# CITY OF NEWTON, MASSACHUSETTS

## ADDENDUM #1

### INVITATION FOR BID #09-102

### COLD PLANNING BITUMINOUS CONCRETE @ VARIOUS LOCATIONS

TYPICAL ROADWAY SECTION BASED ON SIX (6) CORE SAMPLINGS

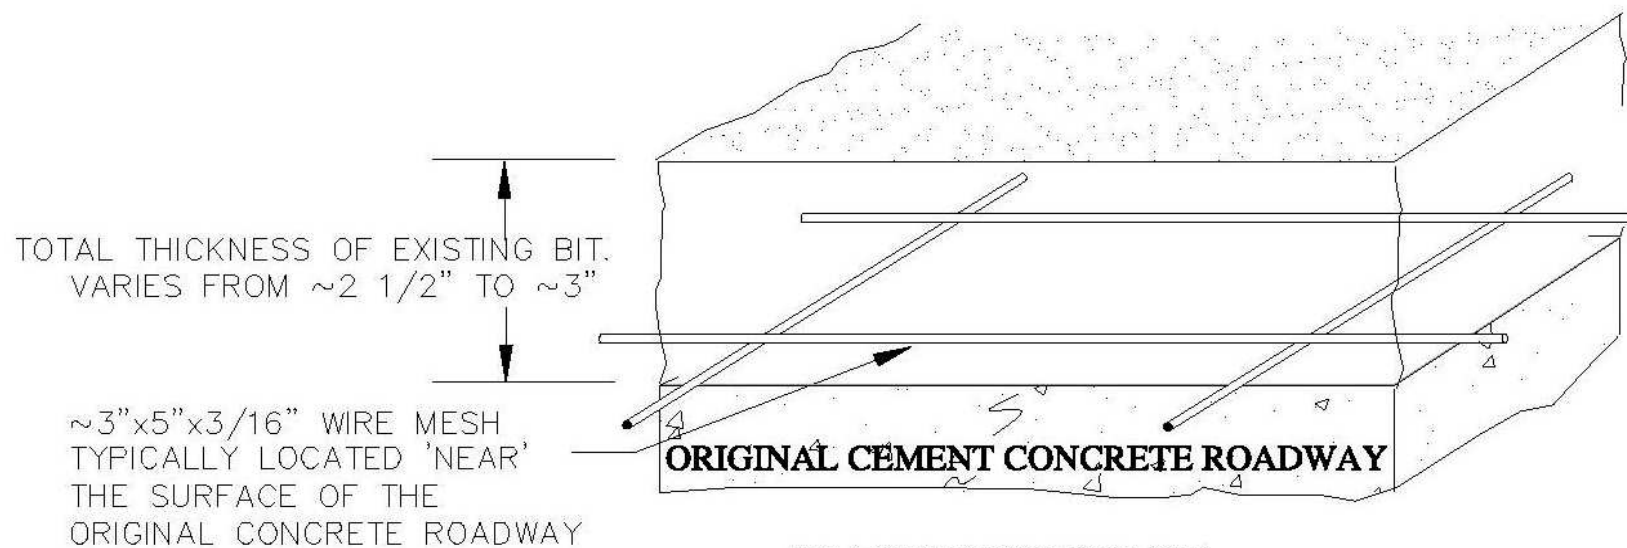
- Q1. In the bid documents on page 31 it states that there is wire mesh in the roadway. Is the wire mesh in the Bituminous Concrete or the Portland cement? If it is in the Portland cement will we be milling into the Portland cement (How thick is the Bituminous overlay)? If the mesh is in fact in the Bituminous Concrete what gage is the wire, what is the spacing of the wire and how deep is it embedded?

- The Portland Cement Concrete (Washington St.) Roadway was overlaid with bituminous concrete (circa 1950's) at which time the wire mesh was installed as an anticipated means of controlling the transverse cracking of the bituminous concrete overlay.
- The wire mesh is now embedded in the existing bituminous concrete overlay and is typically located approximately 1 3/4" to 2" below the existing roadway surface.
- The existing bituminous concrete (overlay) is approximately 2 1/2" to 3" in thickness.
- The wire mesh is Welded Wire Fabric consisting of ~ 3"x 5"x 3/16" Wire Mesh.
- Informational Note: In 2008, during the cold-plane milling of Washington St., the wire mesh was encountered and was exposed in several areas.
- The Contractor will not be milling into the surface of the underlying Portland Cement Concrete Roadway.
- See attached drawing.
